PCN-20210615 TE0820-04 eMMC Change and Product Update

Company	Trenz Electronic GmbH
PCN Number	PCN-20210615
Title	TE0820-04 eMMC Change and Product Update
Subject	BOM change
Issue Date	2021-07-22

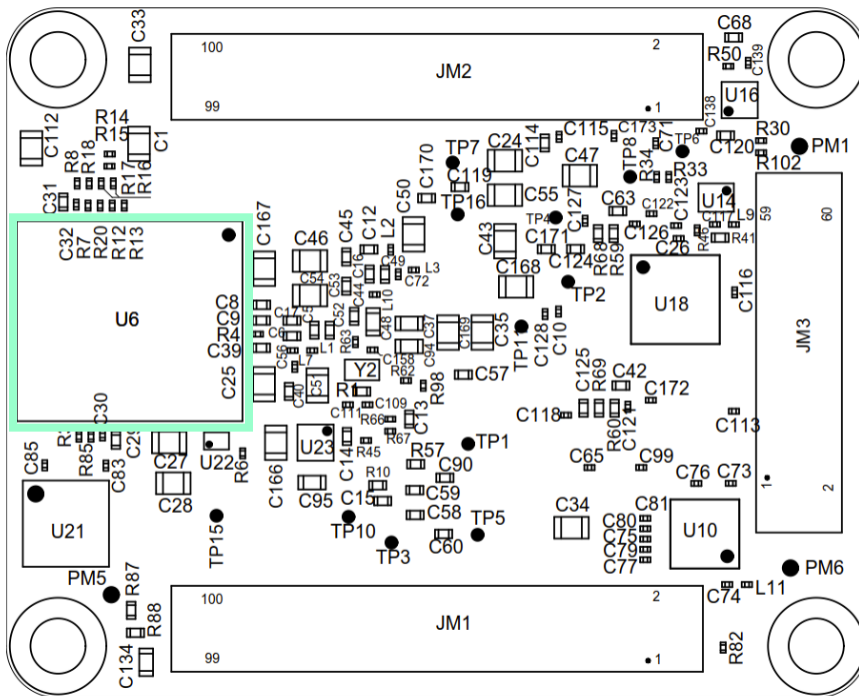
#3 Change Ferrite Beads (L1, L2, L3, L4, L5, L7, L9, L10, L11, L12) BKP0603HS121-T to MPZ0603S121HT000

Type: BOM change

Reason: Part is NRND and EOL announced.

Impact: None. DC resistance decreased from 150mOhm to 130mOhm, rated current increased from 0.85A to 1A.
